World Forum for Harmonization of Vehicle Regulations

Proposal for Supplement 3 to the 08 series of amendments to UN Regulation No. 107 (M₂ and M₃ vehicles)

Supplement 3 to the 08 series of amendments to UN Regulation No. 107 (M₂ and M₃ vehicles)

"Figure 31

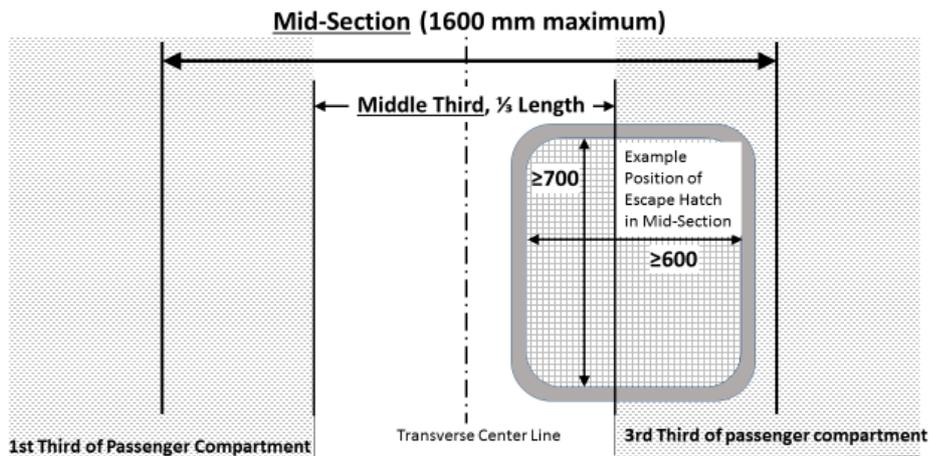
- "7.6.2.9. For vehicles of classes A and B, required escape hatches shall be positioned as follows:
- (a) If there is only one hatch, it shall be situated in the middle third of the passenger compartment. As an alternative, on vehicles with a very short passenger compartment length, the hatch may be located in the mid-section of this compartment, and this mid-section shall be equally spaced longitudinally each side of the transverse centre line of the passenger compartment, with a length of no greater than 1.6m as shown in Annex 4, Figure 31;
 - (b) If there are two hatches, they shall be separated by a distance of at least 2 m measured between the nearest edges of the apertures in a line parallel to the longitudinal axis of the vehicle."

Alternative placement of escape hatch for very short passenger compartment length having a middle third smaller than 1600 mm

(See Annex 3, paragraph 7.6.2.9.)
